## **Addendum 11: Global technical regulation No. 11**

**Test procedure for compression-ignition engines to be installed in agricultural and forestry tractors and in non-road mobile machinery with regard to the emissions of pollutants by the engine**

## **Corrigendum 1**

Established in the Global Registry on 22 June 2011

Figure 7.3  
**Test sequence**

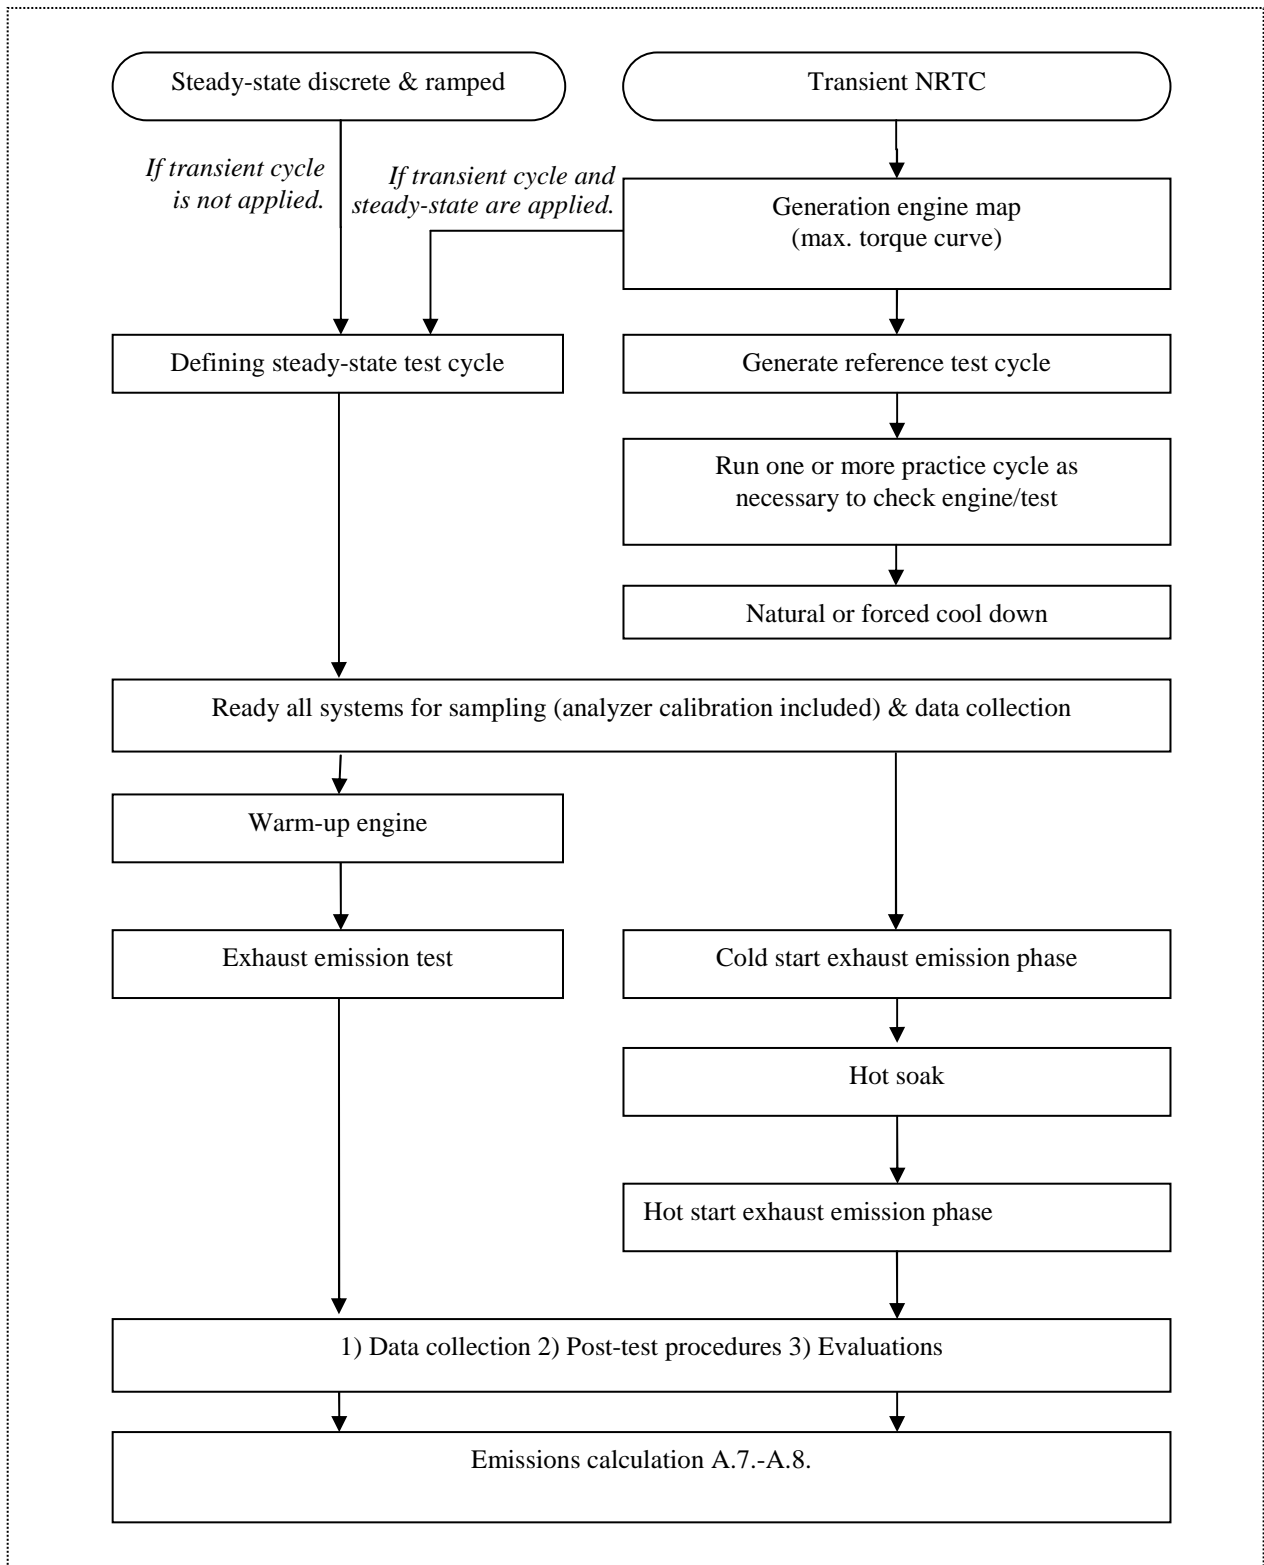
*Paragraph 7.5.*, amend to read:

The following diagram gives an overview about the procedures needed to conduct NRMM test cycles with measuring exhaust engine emissions.

**Schematic diagrams for diluted exhaust flow CVS calibration**

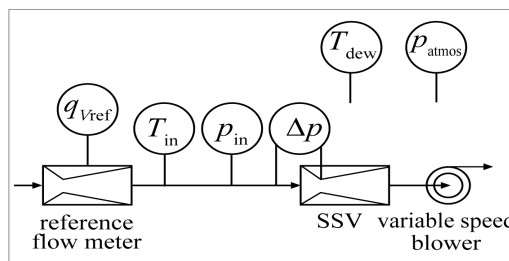
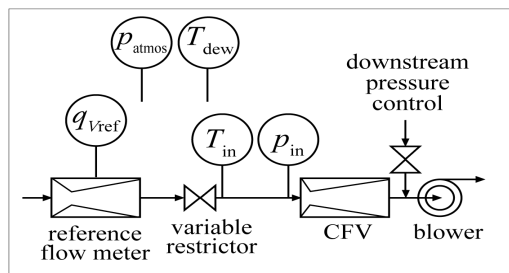
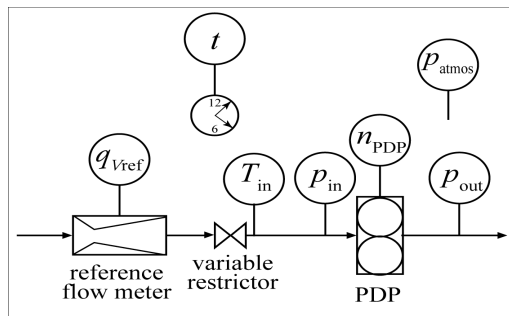
Paragraph 8.1.8.4., figure 8.1, amend to read:

Figure A.4.1

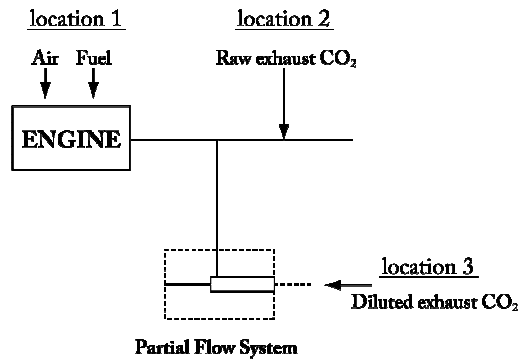
Paragraph A.4.1., amend to read:

Figure A.4.1 shows the sampling points at which the carbon flows shall be checked. The specific equations for the carbon flows at each of the sample points are given in the following paragraphs.

Figure 7.3  
Test sequence

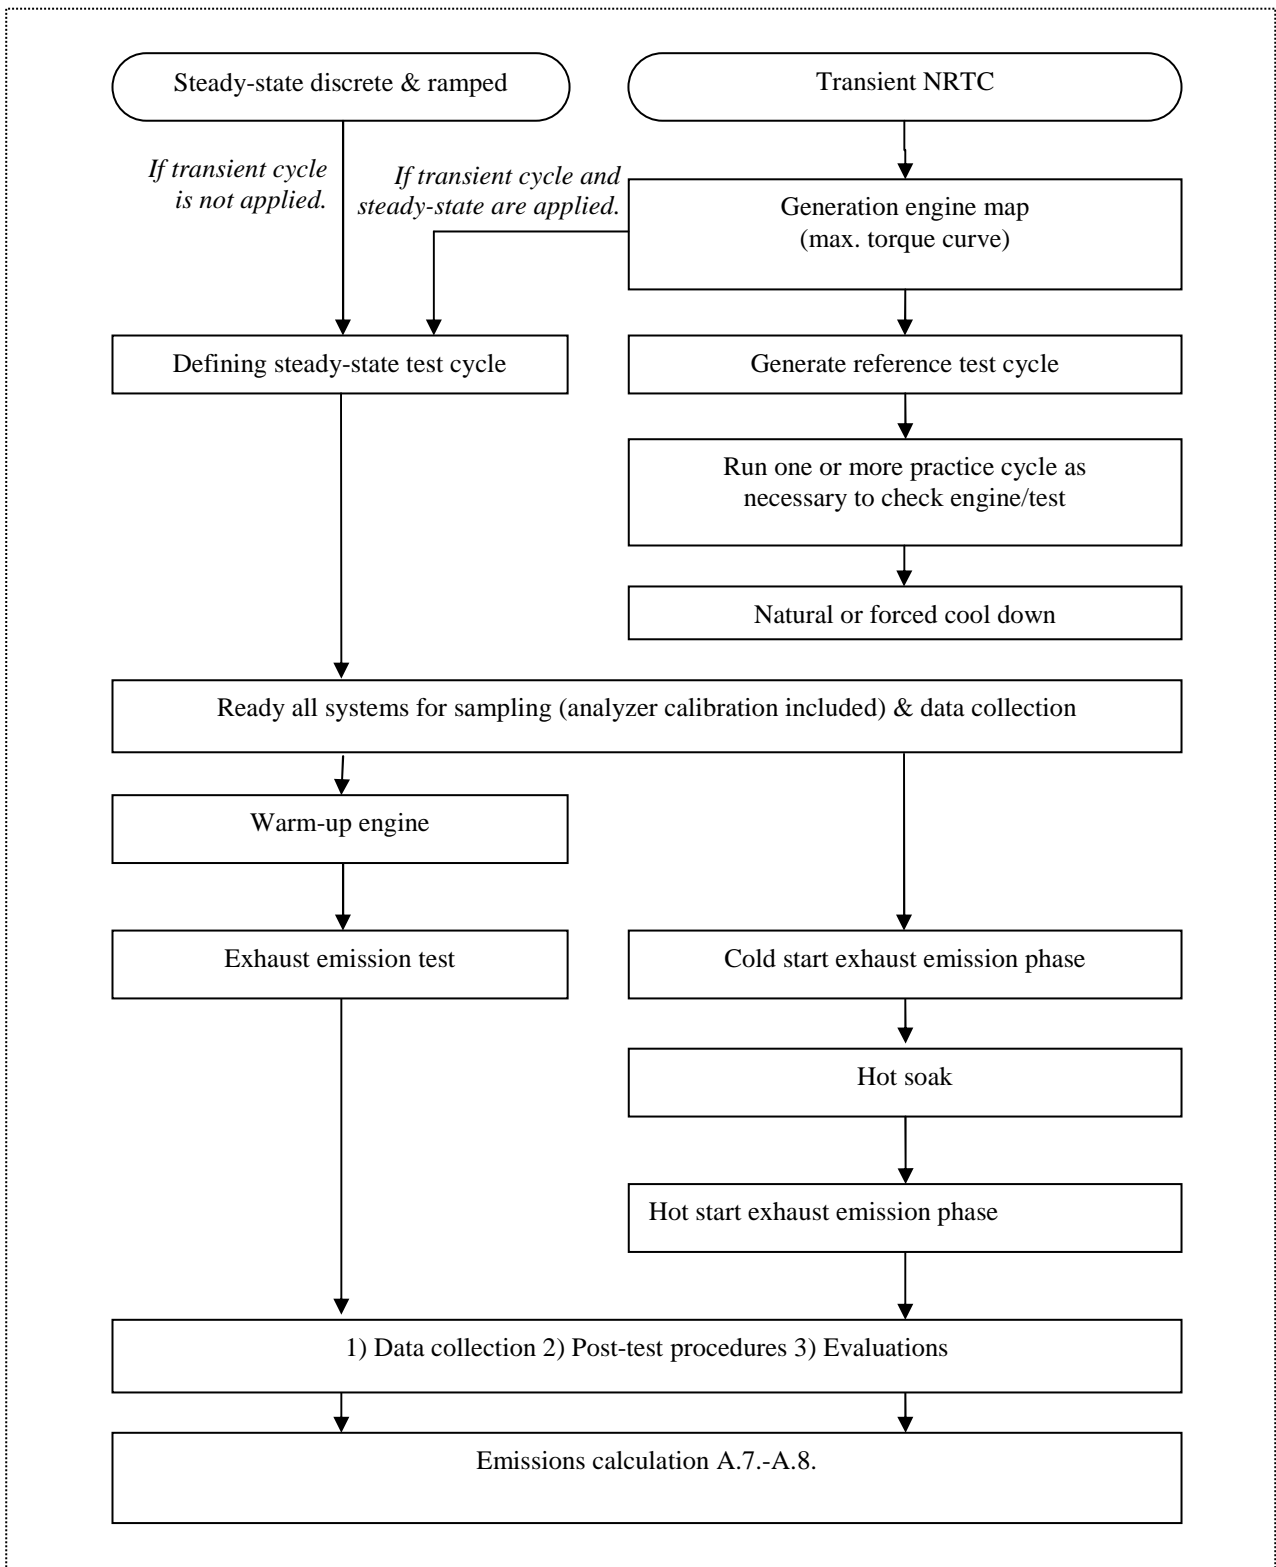
The following diagram gives an overview about the procedures needed to conduct NRMM test cycles with measuring exhaust engine emissions.

"Figure 8.1  
**Schematic diagrams for diluted exhaust flow CVS calibration**

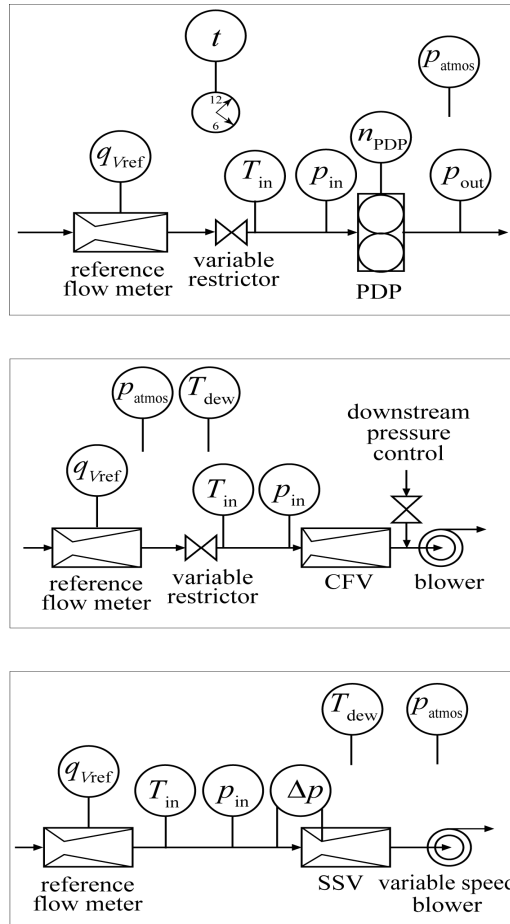
Paragraph 8.1.8.4., figure 8.1, amend to read:

Figure A.4.1

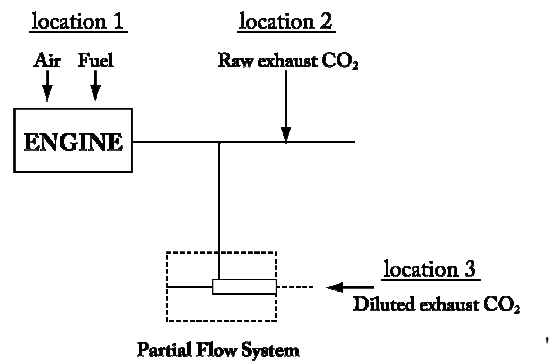
Figure A.4.1 shows the sampling points at which the carbon flows shall be checked. The specific equations for the carbon flows at each of the sample points are given in the following paragraphs.
